ADDENDUM NO. 1

**Upgrade HVAC and BAS System
Hannibal Community Supervision Center
Department of Corrections
Hannibal, Missouri**

Bid Opening Date: 1:30 PM, Tuesday, December 20, 2022

3. Sheet M-501, Enlarged Plans – Mechanical Details

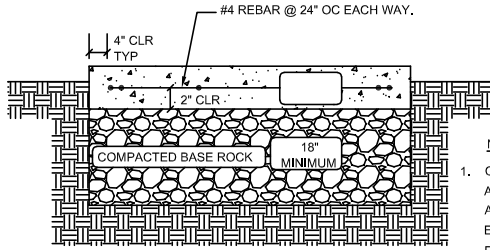
- a. REVISE title "Equipment Pad Detail" to "Exterior Equipment Pad Detail"
- b. ADD Interior Equipment Pad Detail
